H110NAS2  
**TECHNICAL BULLETIN**  
 11 MAY 2018

501-25C: Body Repairs

Service Action: A-Pillar Water Ingress

MODEL:	MODEL YEAR:	VIN:	ASSEMBLY PLANT:
XE (X760)	2017-2018	P10647-P17694	Castle Bromwich

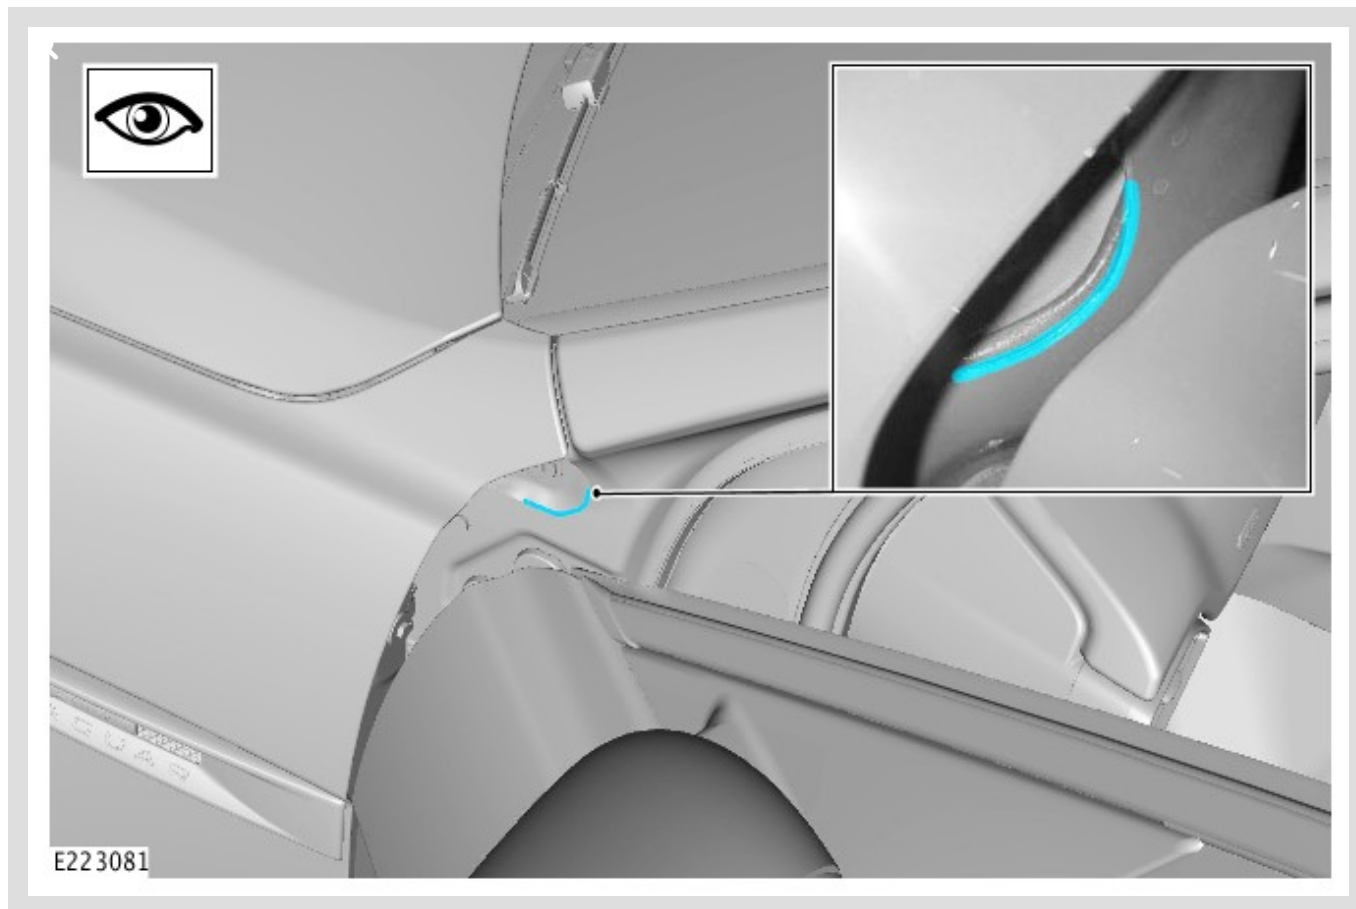
An issue has been identified on certain vehicles within the listed Affected Vehicle Range where due to a change to the robotic sealing process, a small area of sealant at the left and right A-pillar was omitted. As a result of this, water can run through this area into the passenger compartment of the vehicle.

Left A-pillar area shown; right A-pillar area similar.

Area in which water can enter the passenger compartment.
